# Zoning Staff Report

**Case Number:** SP-22-010

**Proposed Use:** Amend Required Site Plan of PD574 for lots 1R and 3R for multifamily and mixed-use

# MONTGOMERY PLAZA SITE PLAN

**ZONING SITE PLAN**  
 SP-22-010  
 PD574

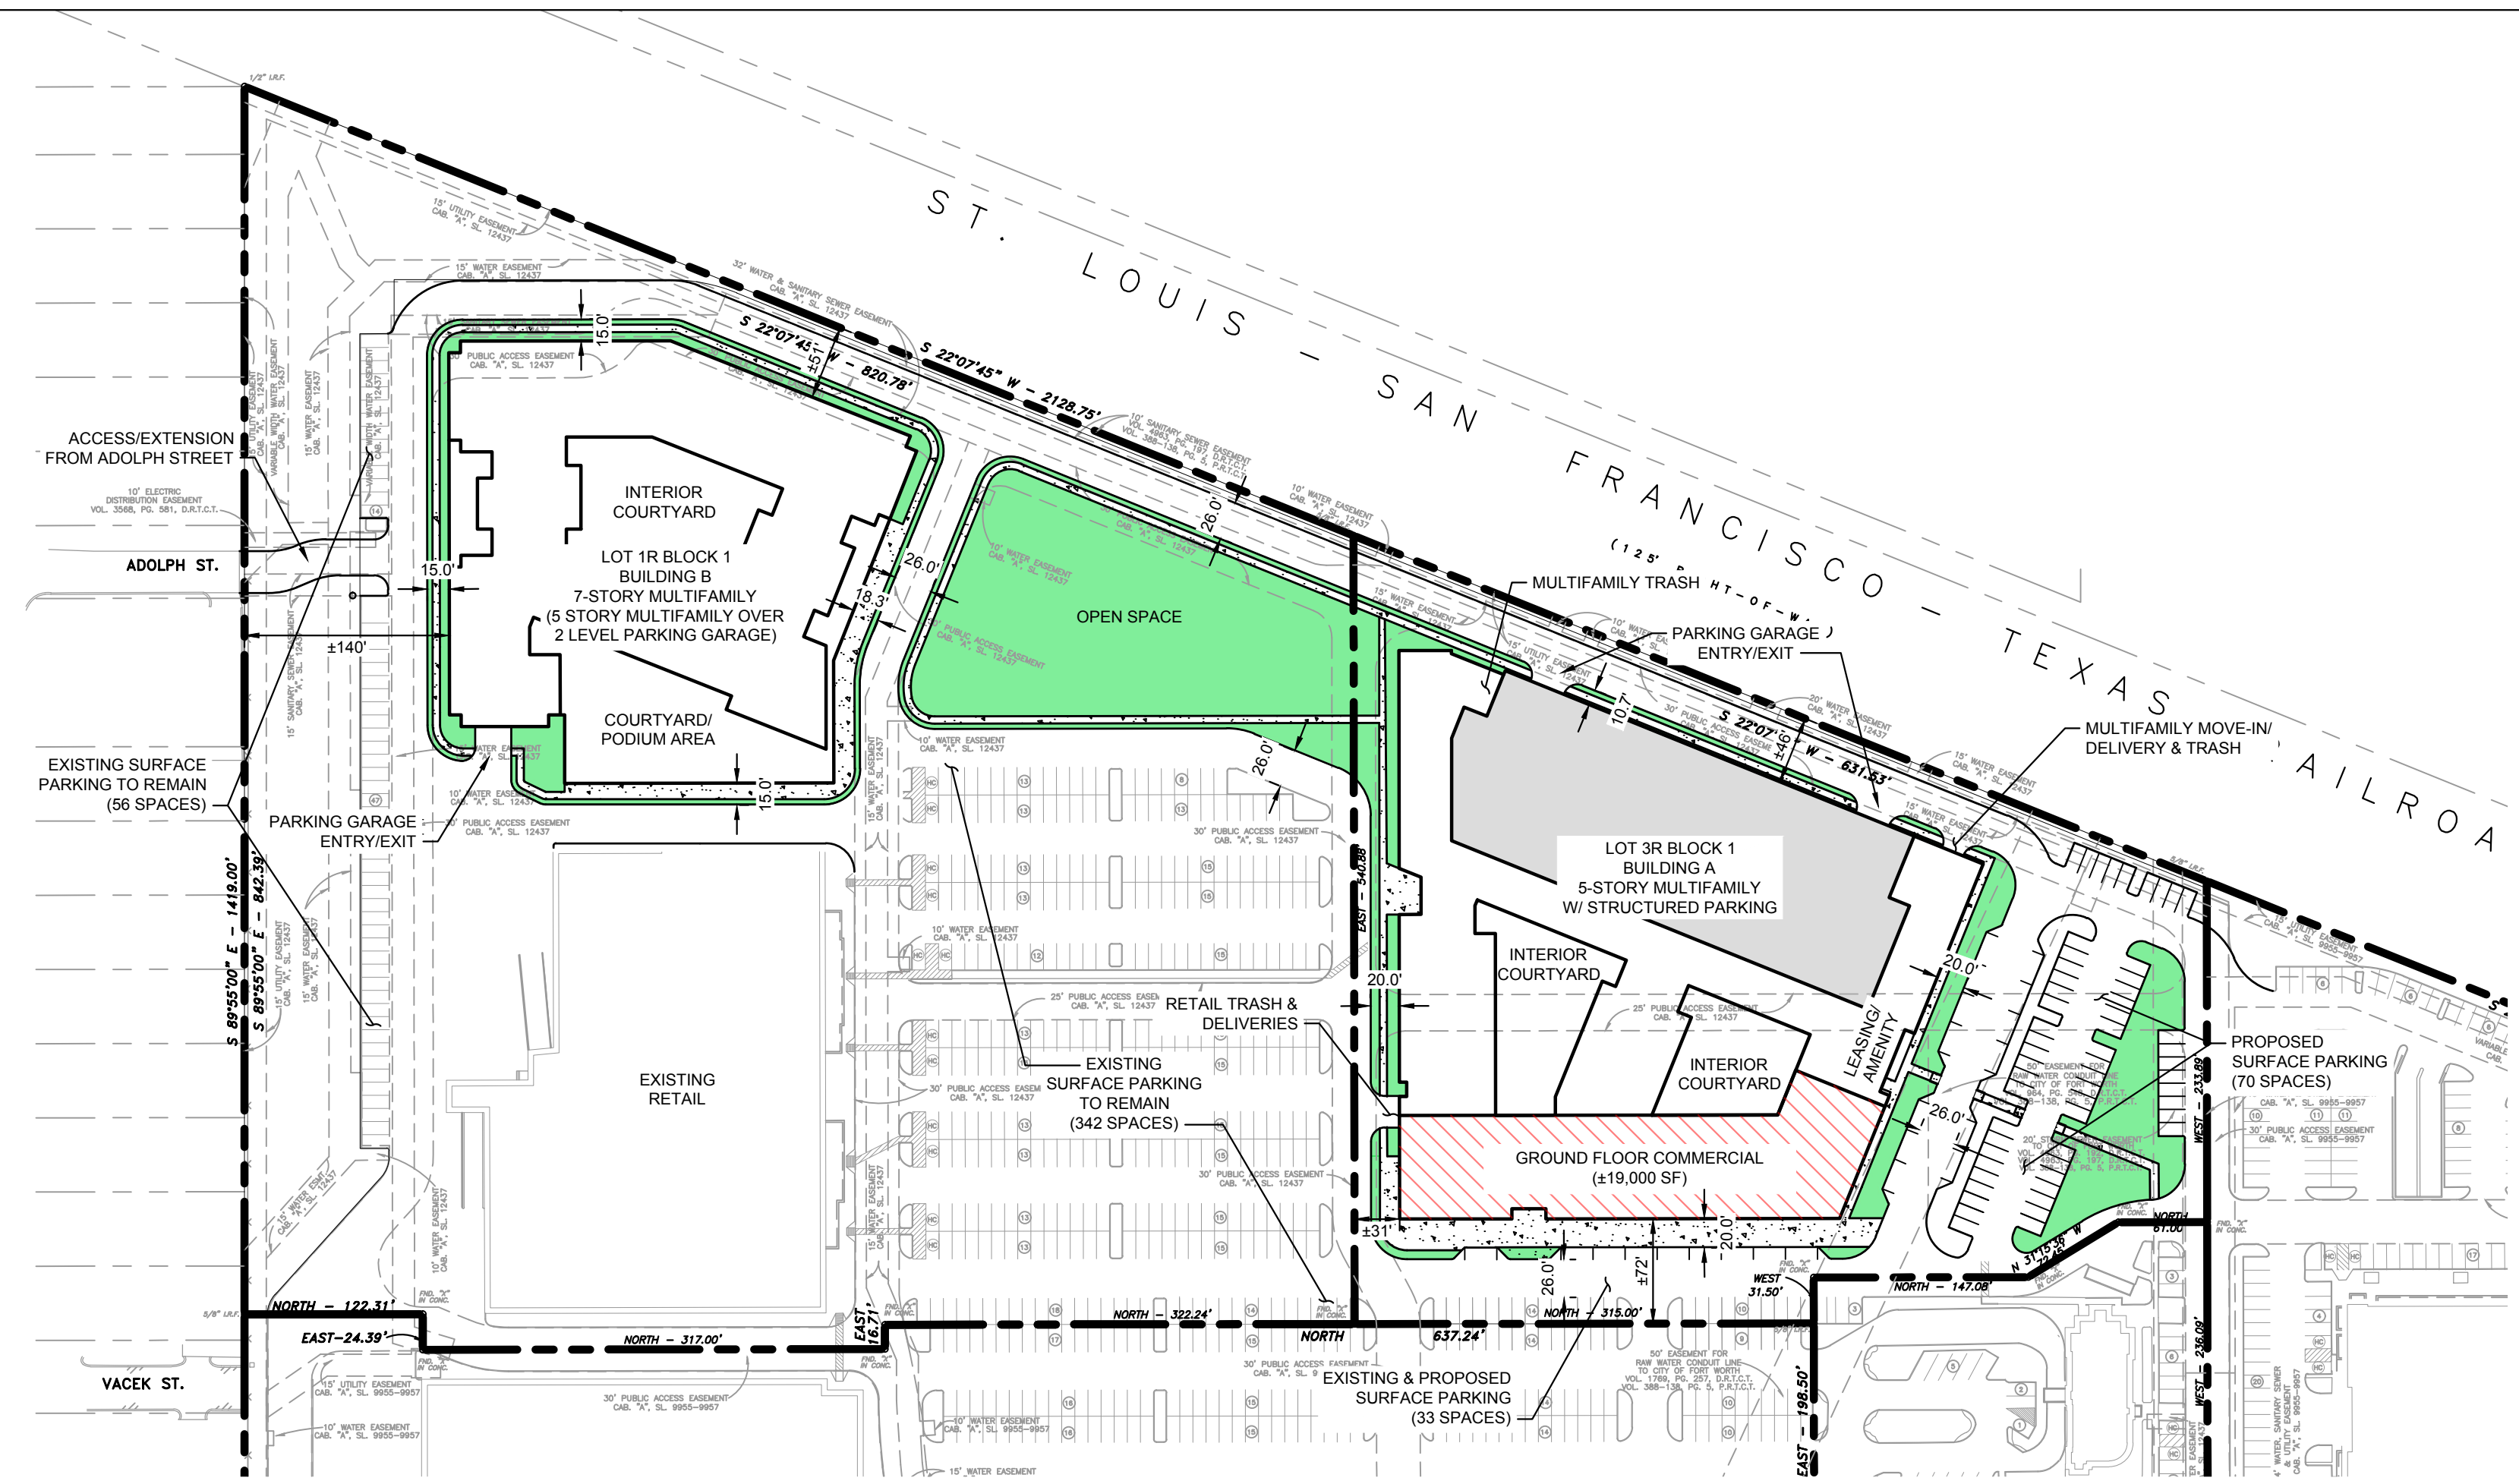
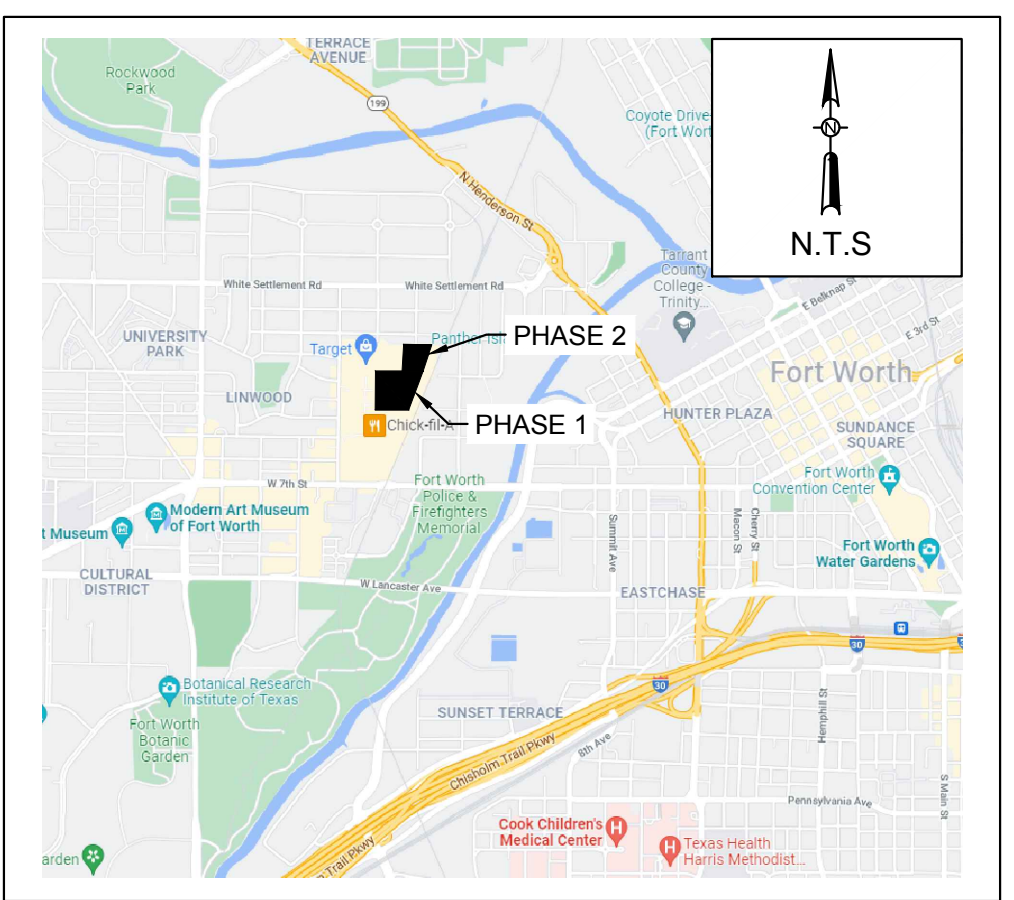
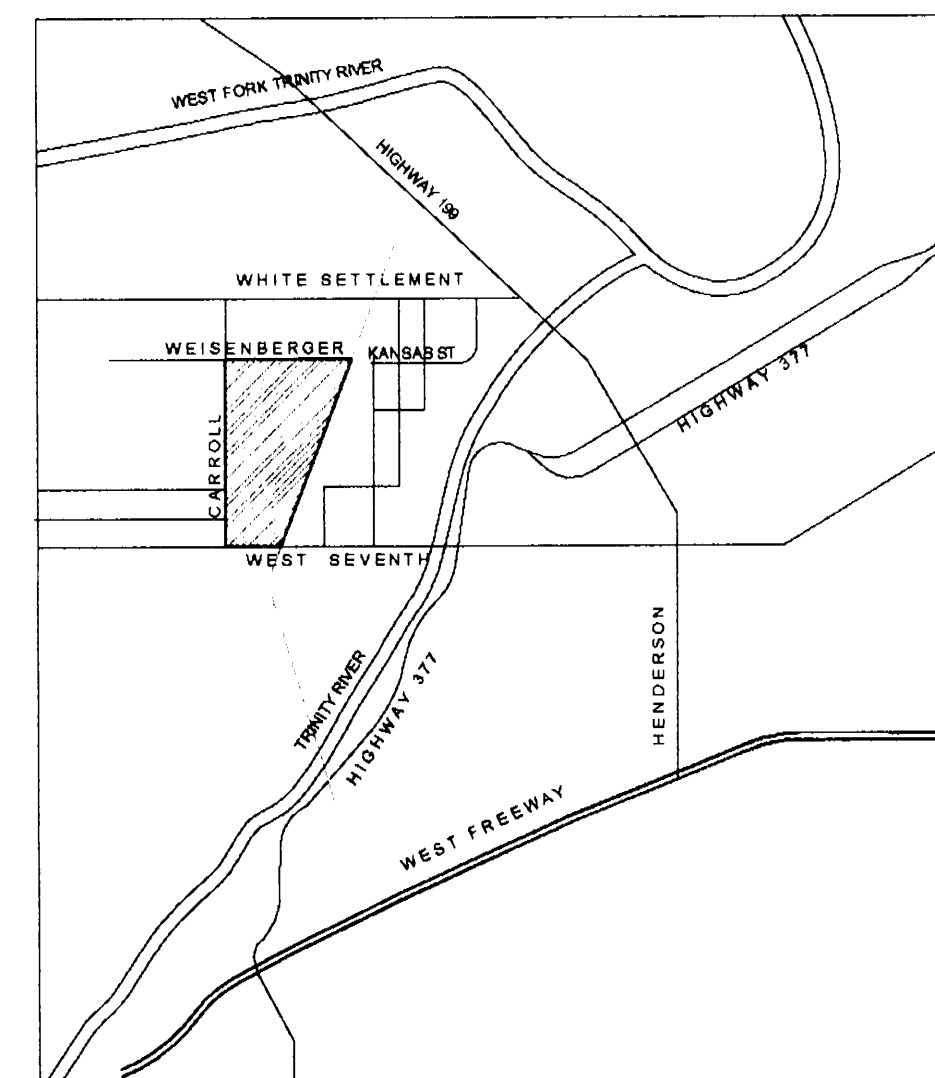
- Plat was not provided with the application documents, but an exhibit of existing and proposed access easements was provided. Platted Public Access Easements affect requirements of the MU-2 Ordinance, such as, but not limited to, the following:

- Setbacks
- To obtain the height bonus for the 7-story building, project must meet requirements of 4.1302(d)(8). Applicant has expressed intent to meet 4.1302(d)(8)b for the Structured Parking height bonus (providing

100% of all off-street parking within the structured parking) and 4.1302(d)(8)c for Open Space (providing a publicly accessible pocket park).

- MU-2 has a maximum parking permitted of 100% of the calculated requirement. Parking calculations provided by the applicant provide for the calculated required parking.

- Surface parking must meet the landscape requirements of 4.1302(f)(3).
- As applicable, any fence or structure that is located within an easement will require permission of the easement holder(s) to encroach. Underground or aerial utilities include electricity, gas, water, sewer, telephone, etc. Awnings that encroach the right-of-way require an encroachment agreement.

- Enhanced Landscaping is not shown on the site plan, but it should be noted that it will be required to meet the Street Trees and Pedestrian Scaled lighting along all Rights-of-Way and all Public Access Easements that are acting as ROW. This note is shown on the site plan.

- Urban Forestry plantings are not shown on the site plan. Project must comply with Urban Forestry requirements per MU-2 standards. This note is shown on the site plan.

- Signs are not shown on the site plan. All signs will conform to Article 4, Signs, and the additional provisions of the MU-2 Ordinance in 4.1302(h)(1). This note is shown on the site plan.

- Parking is being calculated per the requirement established via the original SP-03-055, rather than the current MU-2 standard. This note is shown on the site plan.

- FWFD - (Lt. Donna York, donna.york@fortworthtexas.gov)
- Firefighter Air Replenishment Systems (FARS) are now required for any new building construction with 5 or more floors, 2 or more floors below grade, or 500,000 square feet or more.  
IFC 2021/CFW Adopted Amendments Ordinance #25388-03-2022 Appendix L

- Emergency Responder Radio Coverage Systems (ERCCS) may be required per Section 510. Signal strength testing required for any new building construction having 3 or more floors or anything over 50,000 square feet, or any basements, or any facility having Low-E or RF blocking windows.  
IFC 2021/CFW Adopted Amendments Ordinance #25388-03-2022 Section 510

- Open parking garages may require fire sprinkler systems dependent on their height, size, etc.  
IFC 2021/CFW Adopted Amendments Ordinance #25388-03-2022 Section 903

- All dry pip fire sprinkler systems must meet the 60 second trip time requirement, regardless of volume.  
IFC 2021/CFW Adopted Amendments Ordinance #25388-03-2022 Section 903

- A building where the topmost occupied floor level is more than 55' in height above the lowest level of fire department vehicle access shall be accessible by a public street or fire apparatus access road that is not less than 15' nor more than 25' from the inside curb to the building face along at least 1/2 of the length of 2 sides of the building. The measurement does not need to be contiguous.  
Such buildings shall also be provided with 2 separate and approved fire apparatus access roads. IFC

IFC 2021/CFW Adopted Amendments Ordinance #25388-03-2022 Section 503.1.4 Buildings Taller Than 55'

- Buildings greater than 55 ft. in height and Group E and H occupancies: the two access roads shall be placed a distance apart equal to not less than one half of the length of the maximum overall diagonal dimension of the property or area to be served, measured in a straight line between accesses.  
IFC 2021/CFW Adopted Amendments Ordinance #25388-03-2022 Section 503.1.2  
IFC 2021/CFW Adopted Amendments Ordinance #25388-03-2022 Section 503.1.7 Secondary Access-Multiple-family Residential

- Emergency Access/Fire Lane requirements IFC 2021/CFW Adopted Amendments Ordinance #25388-03-2022. This includes all fire access roads.  
Minimum turn radius: 25' inside and 51' outside (Section 503.2.4)  
Where divided by a median, the minimum width on either side of the median is 20' (Section 503.2.1)  
Minimum of 26' wide for multi-family or for buildings over 55' in height (Section 503.2.1)  
Minimum overhead clearance is 14' (Section 503.2.1)

- Existing hydrants may need to be relocated to meet requirements for hose lay to FDC:  
The Sprinkler and Standpipe FDC shall be located within 50 ft. of a dedicated street or fire apparatus access road shall be within 150 ft. of the fire hydrant. Each building shall be equipped with its own FDC, unless otherwise approved by the fire code official.  
IFC 2021/CFW Adopted Amendments Ordinance #25388-03-2022 Reference Sections 507.5.1, 507.5.4, 5, and 6 Fire Hydrants
